BCA ASSESSMENT REPORT

25-27 Kevin Avenue, Avalon

Project Number: 118132

Date: 26 October 2023

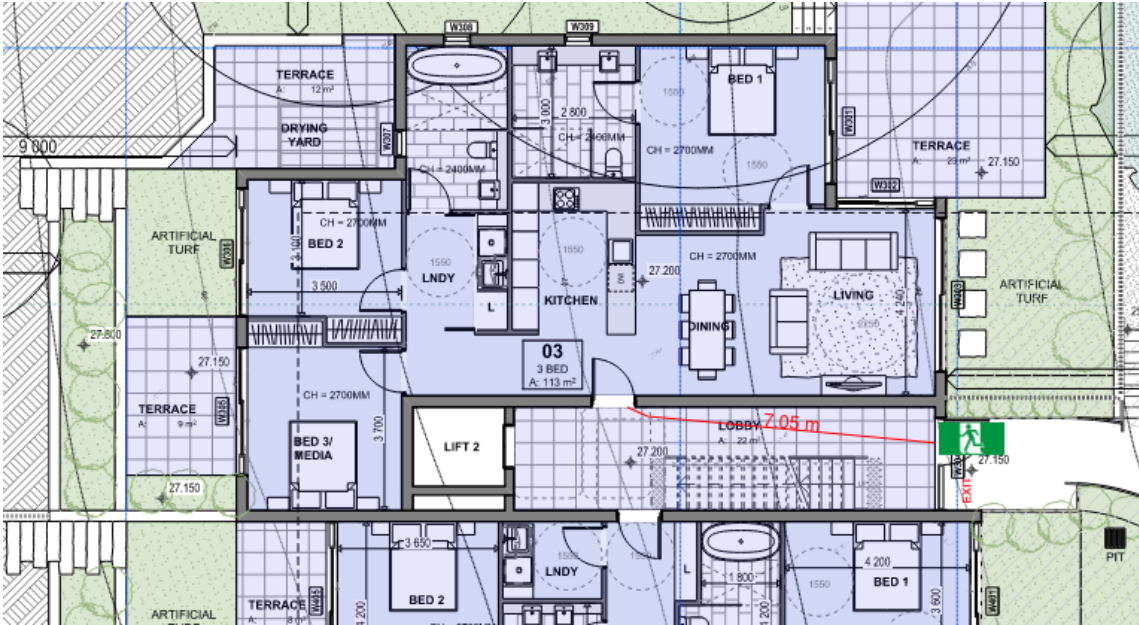
Egress from the carpark is required in sufficient numbers and location to ensure that no point on the floor is more than 20m from an exit, or a point of choice of two exits, in which case the distance to one of those exits is not more than 40m, as required by clause D2D5 of the BCA.

The distance between alternative exits is required by clause D2D6 of the BCA to be no closer than 9m and no further apart than 60m when measured through the point of choice. The travel distances and distances between exits comply with the above requirements.

In the residential portion of the building, the distance to an exit is to be no more 6m from any point on the floor to an exit, or a point of choice of 2 exits in which case the distance between those 2 exits is to exceed 45m.

The following non-compliance is demonstrated against BCA Clause D2D5 which are required to be addressed by a suitably qualified fire engineer as a performance solution:

- > Ground Level - The distance to an exit measures 7.1 metres in lieu of 6 metres.

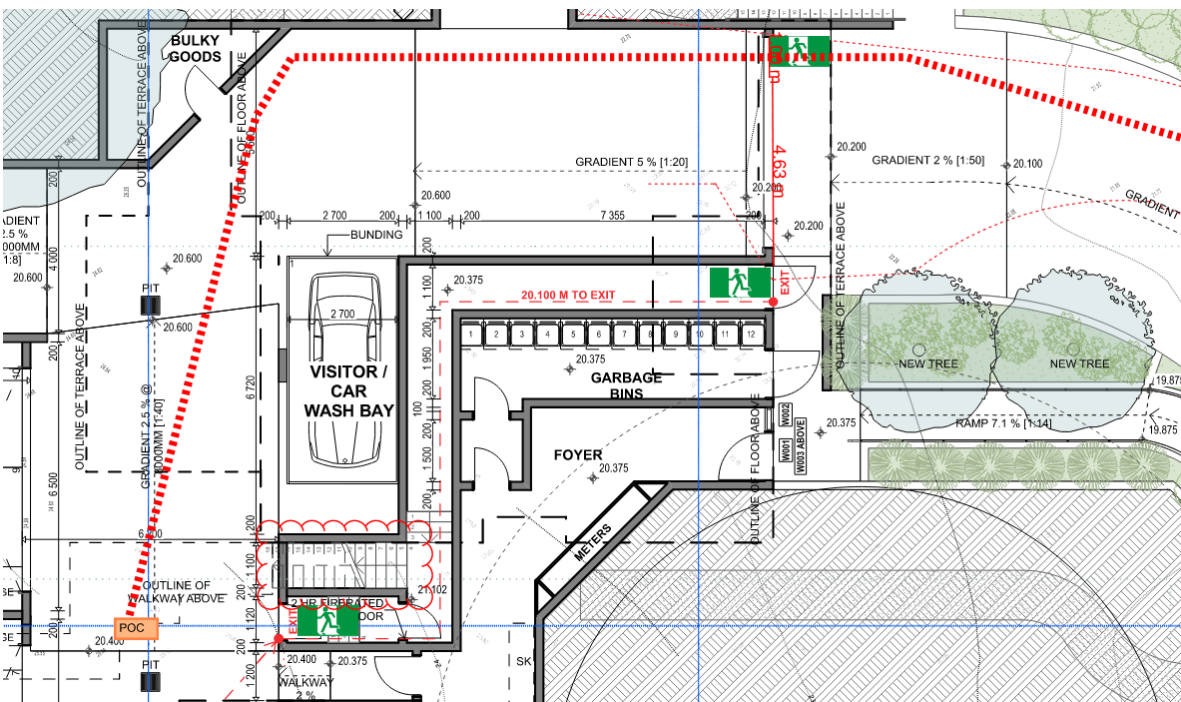
The following non-compliance is demonstrated against BCA Clause D2D6 & D2D15 which are required to be addressed by a suitably qualified fire engineer as a performance solution:

- > Basement Level – Alternative exits on Basement Level are located less than 9m apart. Discharge points for alternative exits on Basement Level are not located as far apart as practical.
